Mayfield Phase 1 – EIA Addendum
EIA Addendum

January 2020

- 1.4 An update to Planning Application Ref.: 124972/FO/2019 is required during determination because amendments are sought to the details of the application submitted with regards to quantum and associated design co-ordination relating to Baring Street Office 1 and Baring Street MSCP.

Figure 1-3 Modelled Geometry Phase 1 Application 1 in existing surroundings mitigation

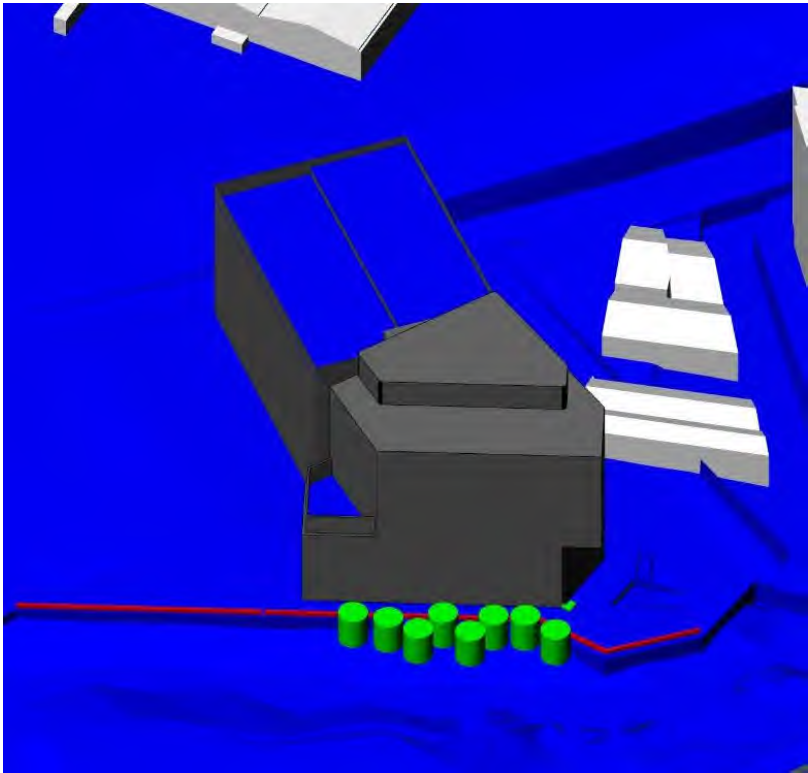
1.3.5 The agreed and tested mitigation for Application 1 is listed in Table 1-1 and shown in Figure 1-3 below.

Mitigation tested in Application 1 in existing surroundings scenario.
One 2m by 2m low-level planter, including shrubbery up to 0.5m at the northern corner of Plot O.
A 50% porous 1.1m tall balustrade at the podium contention wall from the Park.
A series of eight, 7m tall trees to the North of the Plots O and M, inside the Park, according to the Landscape design.

Figure 1-4 Phase 1 Application 1 in existing surroundings - summer composite comfort map (12 wind directions)

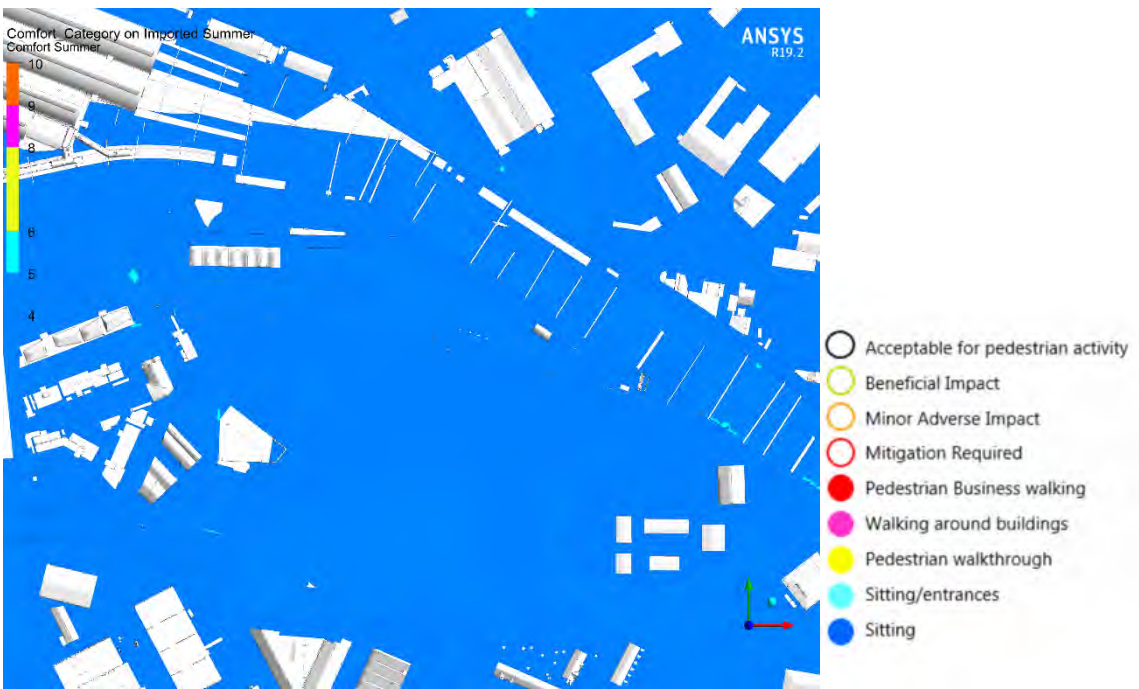
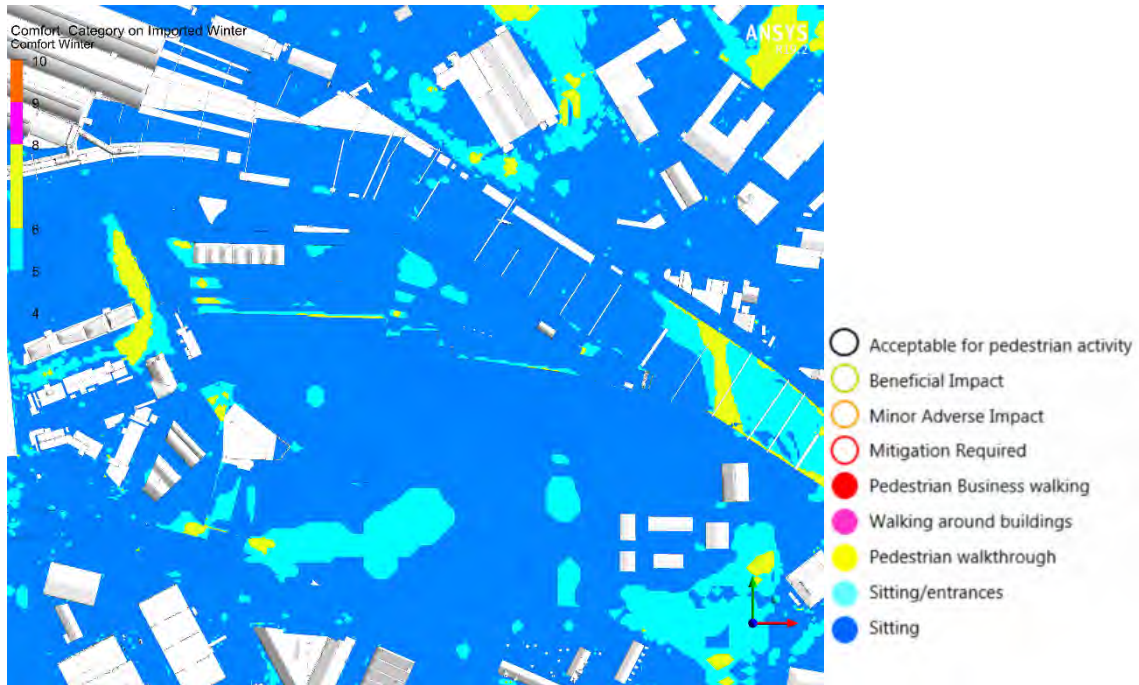
1.3.6 The updated test results show very similar operational effects to those reported in the October 2019 ES. However, a slight reduction to windy areas in yellow (suitable for pedestrian walking) is noticed, mainly produced by the reduction of height of Plot N. In line with the October 2019 ES, no safety concerns have been identified. Conditions for summer and winter for Application 1 wind effects are presented in Figures 1-4 and 1-5 below.

Figure 1-6 Modelled Geometry Phase 1 Application 1 and Application 2 in existing surroundings mitigation

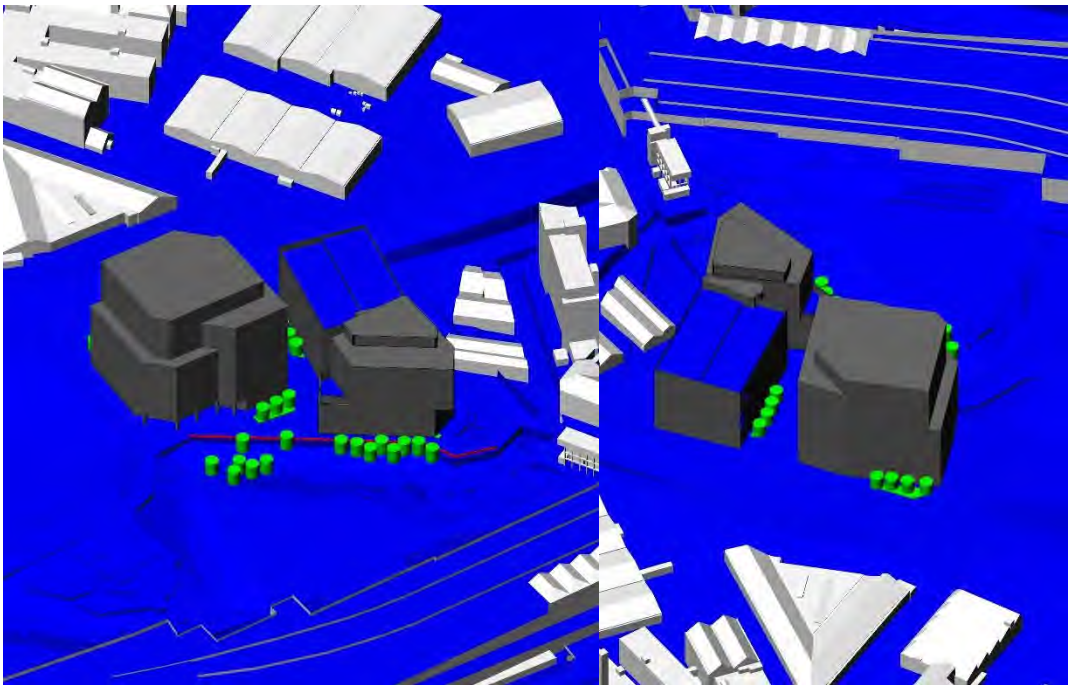
1.3.7 In this scenario there are two main changes in the proposed development from the October 2019 ES; The first one is the reduction of the height of Plot N by 3m, the second is the increase of the height of the cantilever to the north of Plot O. The mitigation strategy remains unchanged from that proposed in the October 2019 ES. The agreed and tested mitigation is listed in Table 1-2 and shown in Figure 1-6 below.

Mitigation tested in Application 1 and Application 2 in existing surroundings scenarios.
One 2m by 2m low-level planter, including shrubbery up to 0.5m at the northern corner of Plot O.
A 50% porous 1.1m tall balustrade at the podium contention wall from the Park.
A series of fifteen, 7m tall trees to the North of the Plots O and M, inside the Park, according to the Landscape design.
Three, 7m tall trees to the northwest corner of Plot M, including a lower level planter with shrubbery up to 1m tall.
Four, 7m tall trees to the southeast corner of Plot M, including a lower level planter with shrubbery up to 1m tall.
Four, 7m tall trees to the east of Plot N, including a lower level planter with shrubbery up to 1m tall.

Figure 1-7 Phase 1 Application 1 + Application 2 in existing surroundings - summer composite comfort map (12 wind directions)

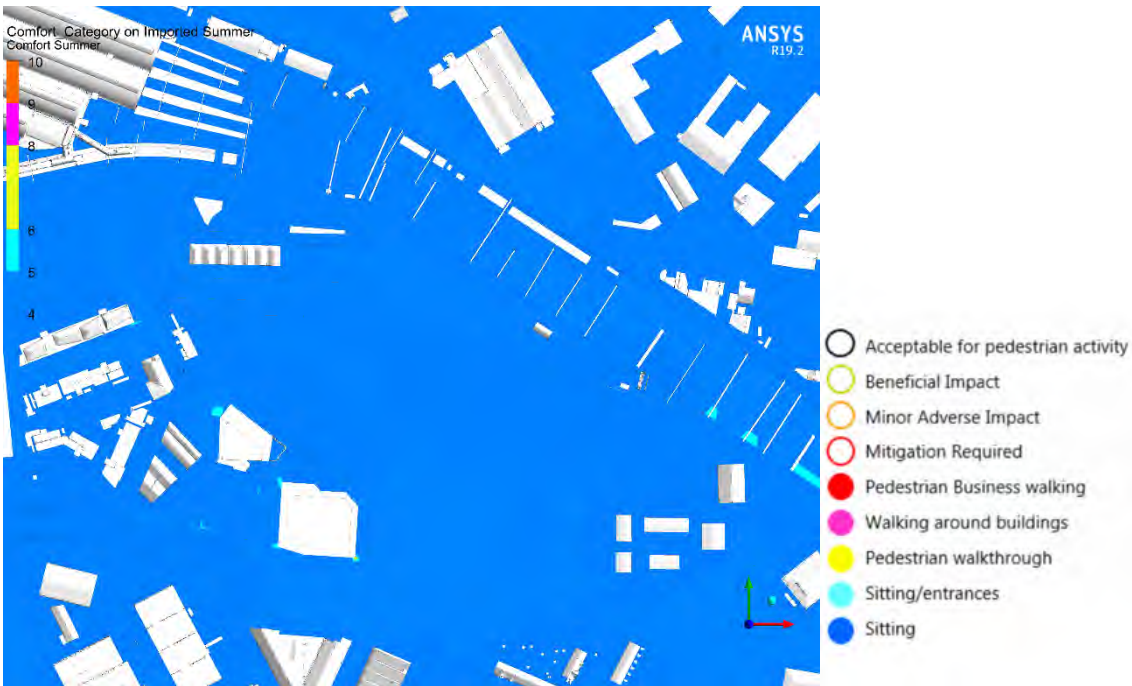
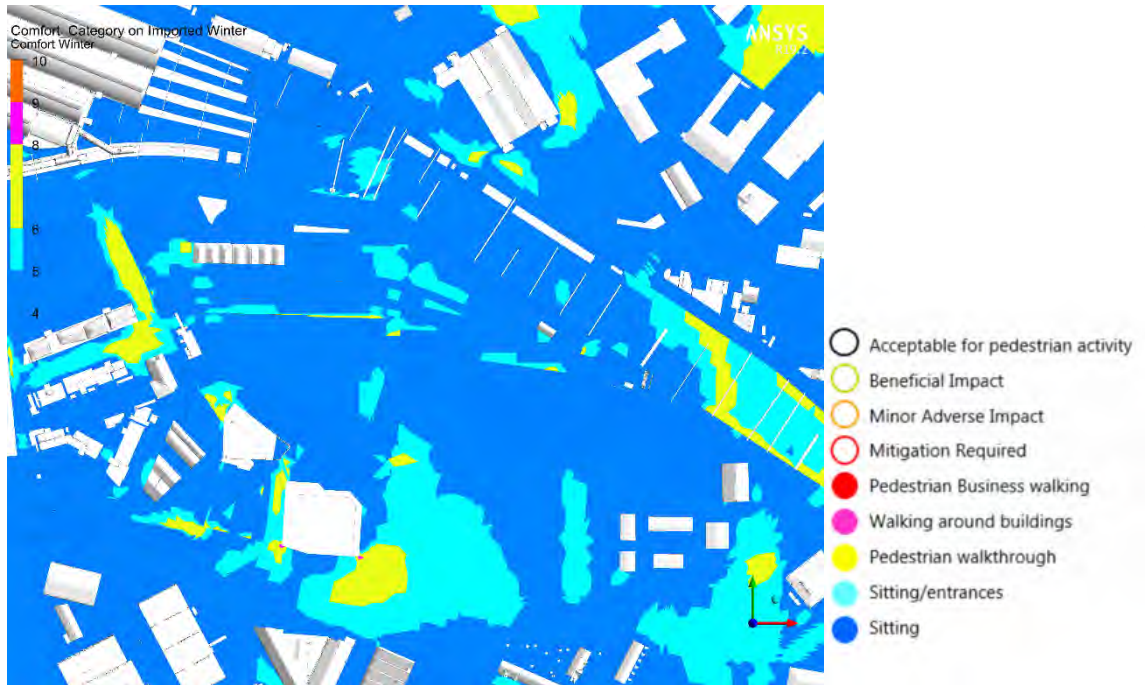
1.3.8 The operational effects remain unchanged from the October 2019 ES. A slight reduction in windy areas is, however, noticed mainly due the height reduction of plot N. In line with the October 2019 ES, no safety concerns have been identified. Conditions for summer and winter for Application 1 and Application 2 wind effects are presented in Figures 1-7 and 1-8 below.
